Oil Leakage in the Area of the Upper Part of the Oil Pan and Crankcase: Checking Return Seal on Upper Part of Oil Pan and Replacing if Necessary (91/24)

Vehicle Type: **911 Carrera (992) / 911 Carrera S (992) / 911 Sport (992) / 911 Carrera GTS (992) / 911 Carrera T (992) / 911 Carrera 4 (992) / 911 Carrera 4S (992) / 911 Carrera 4 GTS (992) / 911 Targa 4 (992) / 911 Targa 4S (992) / 911 Targa 4 GTS / 911 Turbo (992) / 911 Turbo S (992) / 911 Dakar (992)**

Concerns: **Oil pan return seal**

Oil leakage area

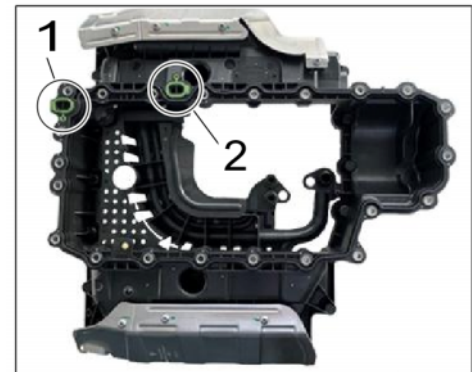
Cause: **Oil traces are detected on the oil pan on the side of the engine transmission flange.**

The leak is located in the area of the sealing point between the upper part of the engine oil pan and crankcase ⇒ *Oil leakage area -Circle-*, on green return seal ⇒ *Oil leakage area -1-* in the “window section” of the upper part of the oil pan.

Action: Check the return seal in the area of the “window section” and replace it with a **new component status** if applicable.
